SERVICE & PARTS TECHNICAL INFORMATION

79-A-2

CYLINDER HEAD GASKETS

TR7

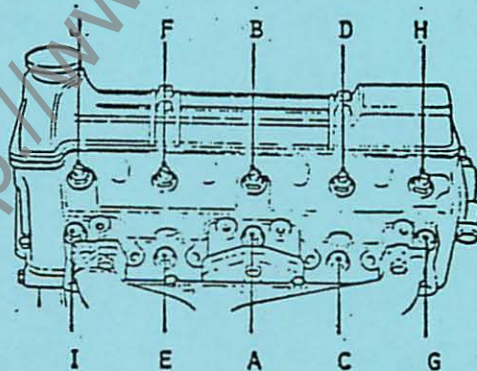
The following torque and cylinder head tightening sequence must be used when fitting cylinder head gasket, part no. GEG 3304.

TORQUE 45-50 lbs/ft.
